APPENDIX D
REPORT OF DESIGN PANEL

The Design Panel was assigned the task of reviewing the design of the systems involved in the Apollo 13 accident, including their qualification history. The service history of the specific components flown on Apollo 13 was also to be examined from a design point of view to ascertain whether any abnormal usage experienced might have had a detrimental effect on the functional integrity of the components. The Panel was also charged with review of other spacecraft systems of similar design or function to ascertain whether they contained potential hazards. Finally, the Panel was to analyze, as required by the Board, proposed failure mechanisms to the extent necessary to support the theory of failure.

REVIEW AND ANALYSIS

Figure D3-14.- Cross section of thermostat.

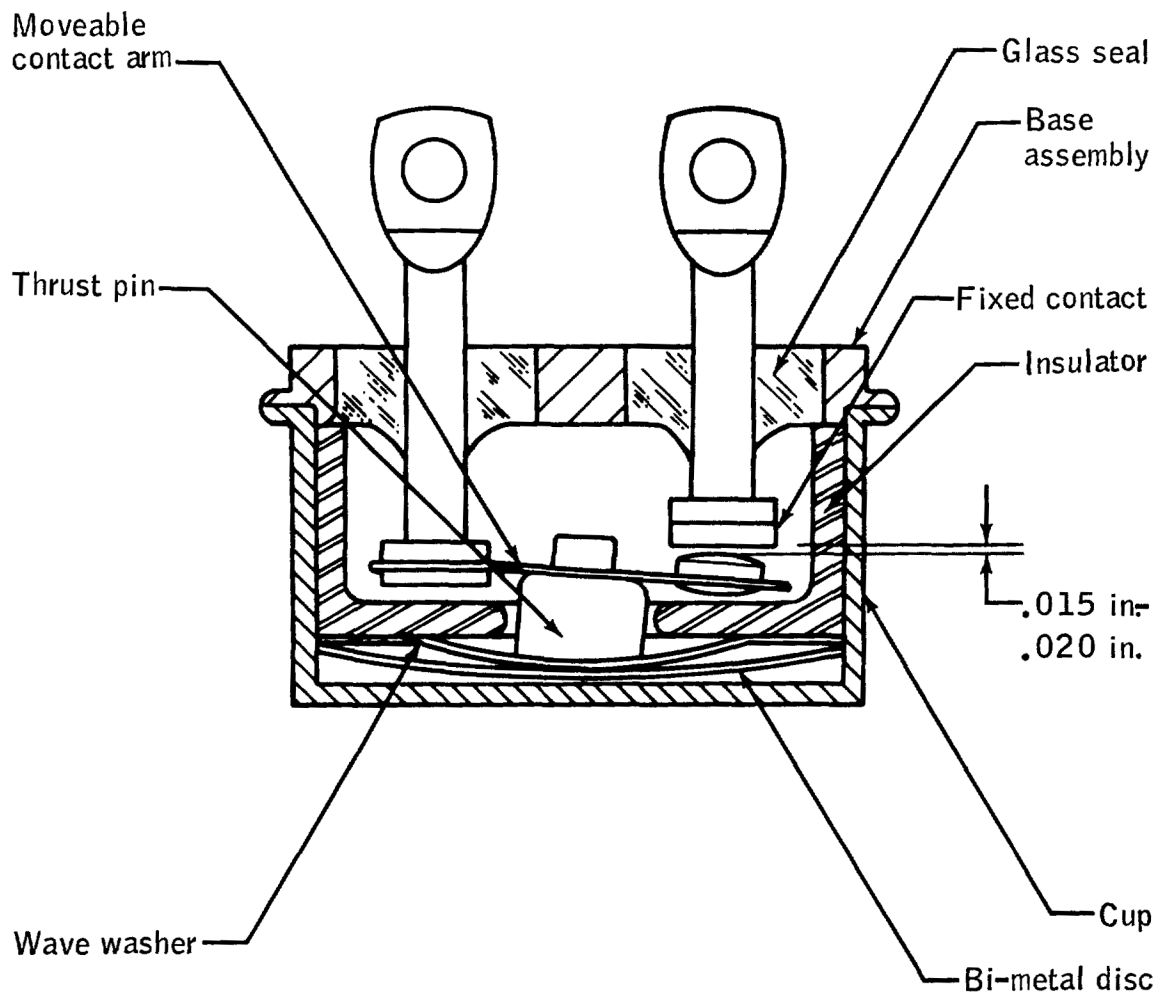
The combination of incomplete, unclear, and therefore inadequate specifications of the thermostat with respect to voltage type and level and a test program that does not verify the ability of the switch to operate satisfactorily under service conditions constitutes a design deficiency. The fact that the ratings for the thermostat by the manufacturer (preceding table) contains no entry for 65 V dc indicates that service at this voltage was not intended.

Figure D3-18.- Arrangement of head end of tank.

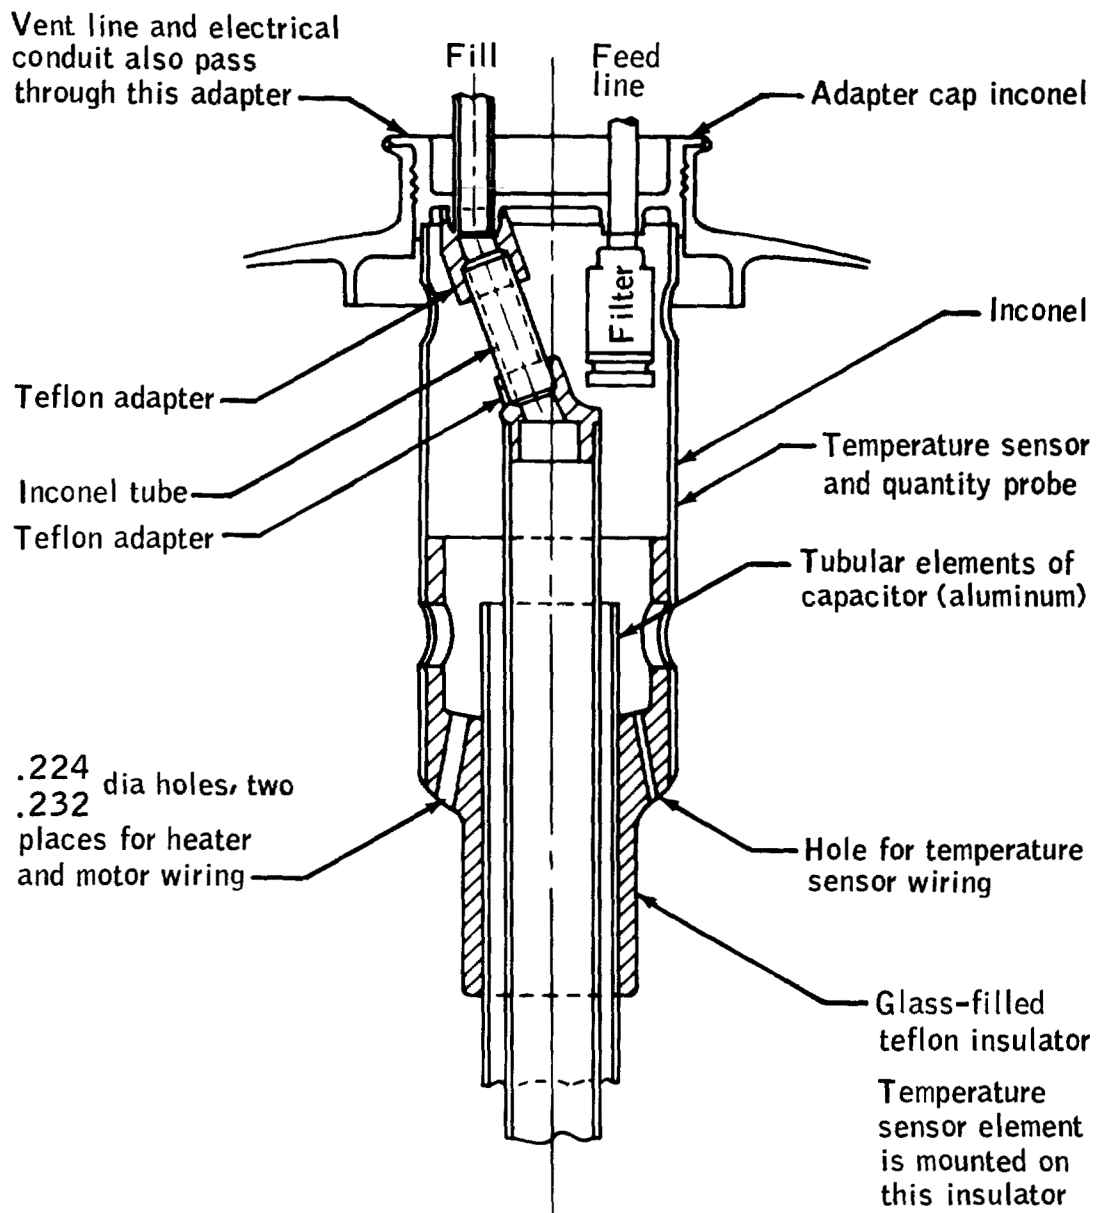
The head ends of the tank and the temperature sensor and quantity probe are shown in figure D3-18. One of the more significant features of the design is the arrangement of the connections in the fill line which routes the cryogenic fluid to the bottom of the tank, via the inner element of the quantity gage capacitor, and which permit the fluid to flow from the bottom of the tank during ground detanking. The manufacturing drawings of the elements of this connection, two Teflon adapters and an Inconel tube, allow a tolerance stack which is excessive. One combined worst case results in a connection which cannot reach from the fill tube connection in the tank head to the center element of the quantity gage capacitor. The other results in a connection length which prevents assembly of the probe to the adapter in the head of the tank. These are shown in figure D3-19. The tolerances on concentricity between the inner element of the capacitor and the outer shell of the probe are not known and are omitted from this figure. Inclusion would show an even worse situation than shown.

One way to obviate this problem would be to redesign the internal components of the tank to permit bench assembly and thorough inspection of a single assembly, embodying all internal components and their plumbing and wiring, before introduction into the tank body. It is recognized that a redesign of this magnitude would largely destroy the foundation of experience, both ground and flight, with respect to the operational characteristics of the tank, but it is difficult to see how the internal details of the tank could be modified to provide the necessary degree of post-manufacturing inspectability without abandoning the present side-by-side arrangement of quantity probe and heater.

Figure D3-19.- Possible variations in fill line connection.

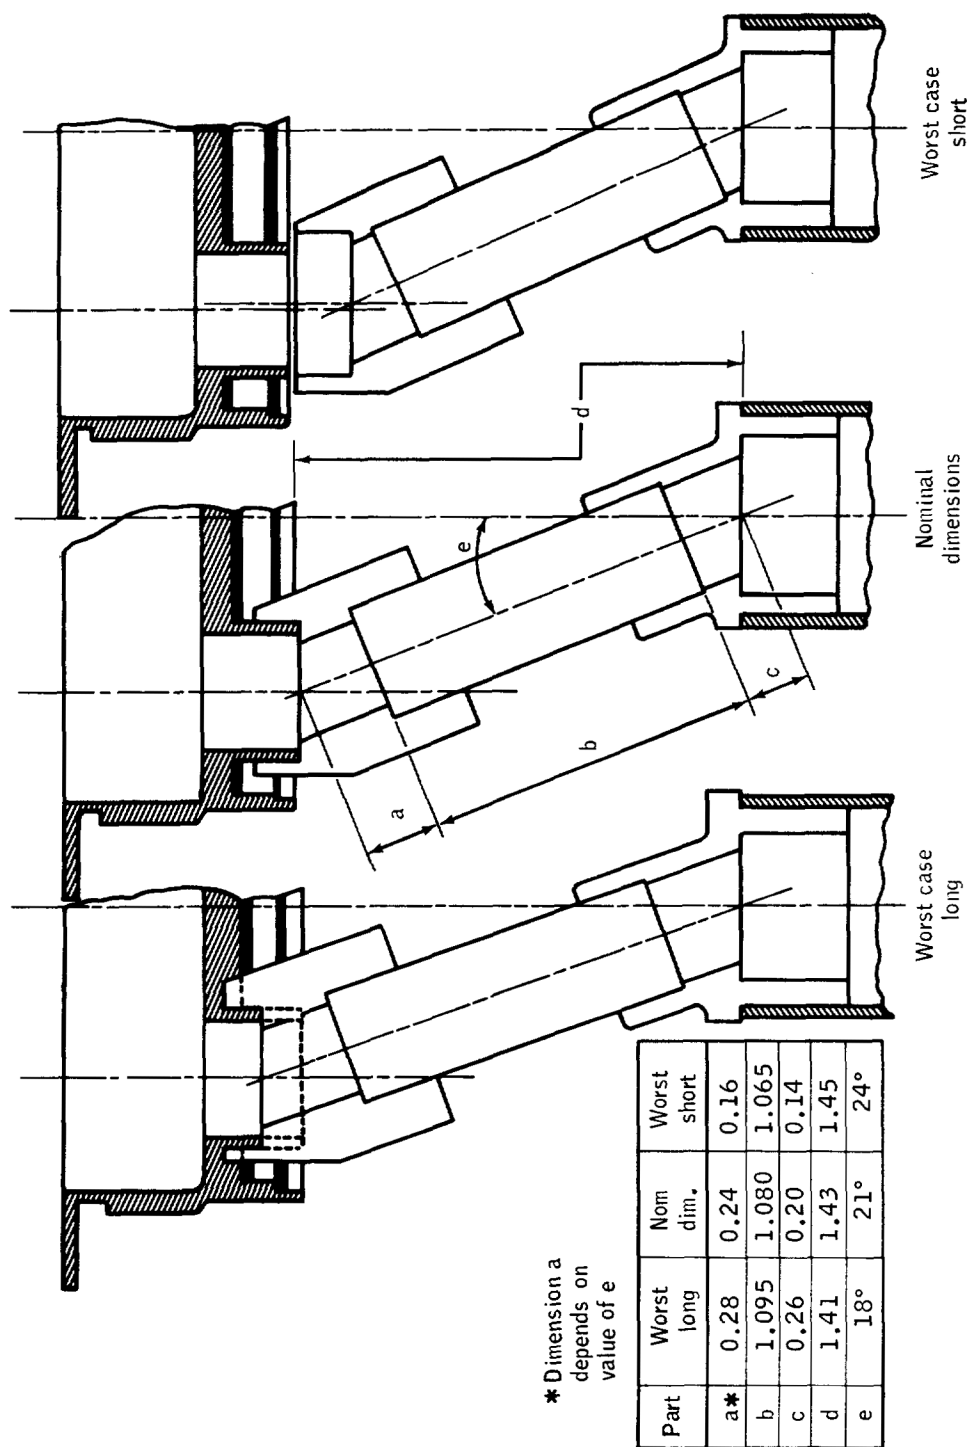
The manufacturing drawing tolerances are such that parts conforming to the drawings could result in an assembly which will not provide the proper connection. However, the probability of a combined worst case is extremely low. It is probable that the actual variations between production parts are significantly less than the drawing tolerances would permit, particularly the variations between parts within a common batch. Data have been requested on other similar parts to determine whether the variations from part to part are large or small, and whether the average tolerance stack found in practice leads to long or short connection assemblies.

Figure D3-21.- Arrangement of tubing within tank dome assembly.

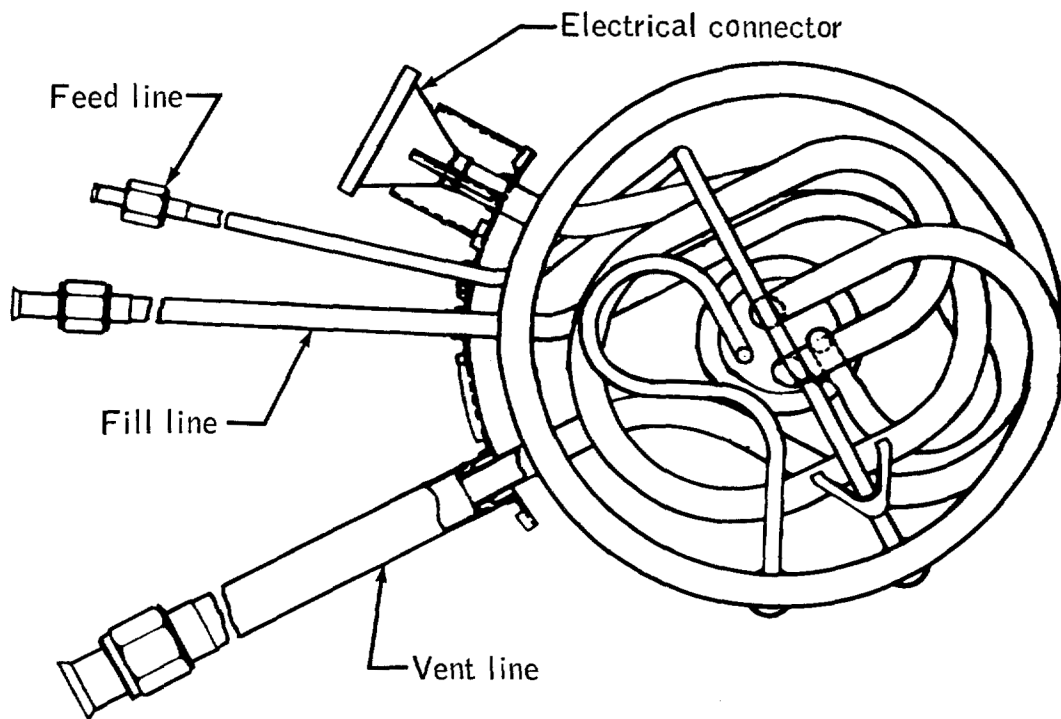
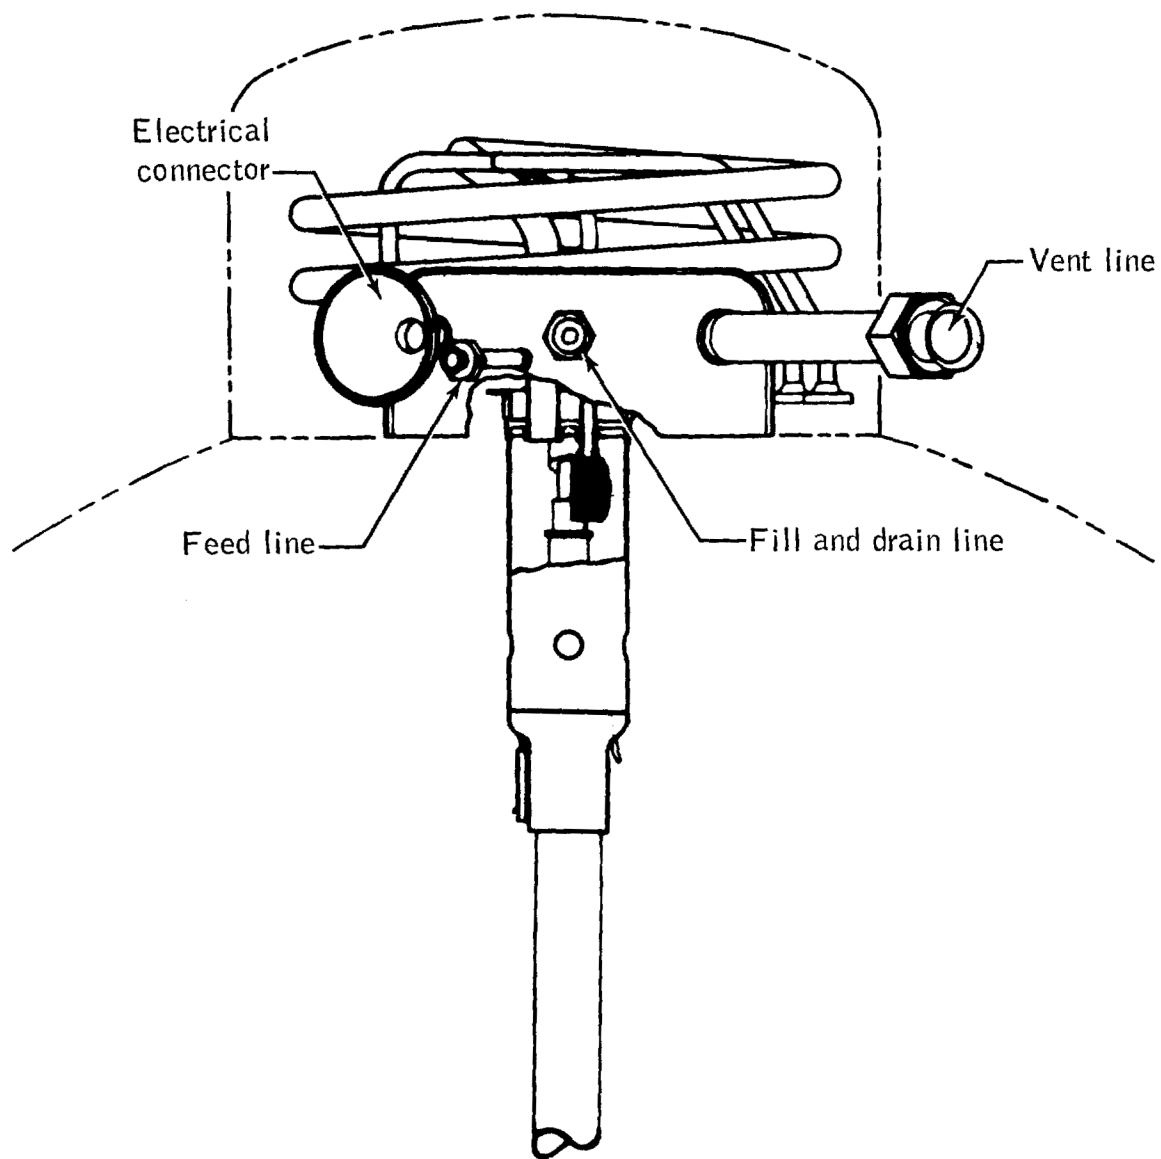
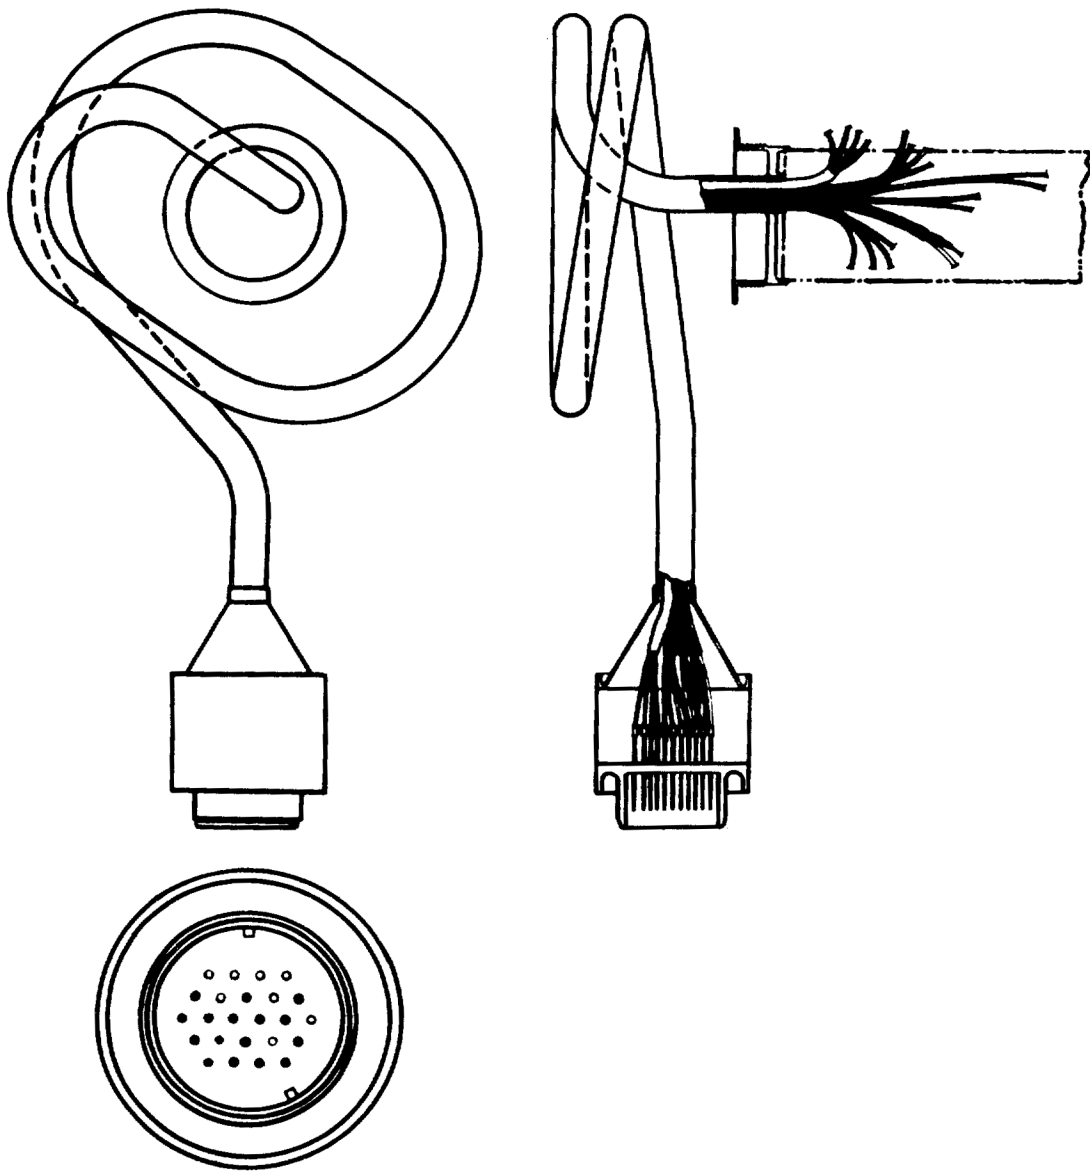
The design of this portion of the tank results in a configuration in which it is not possible to perform visual inspection of wiring after assembly. In consequence, the possibility of damage, in many cases undetectable by normal quality assurance procedures, is significant.
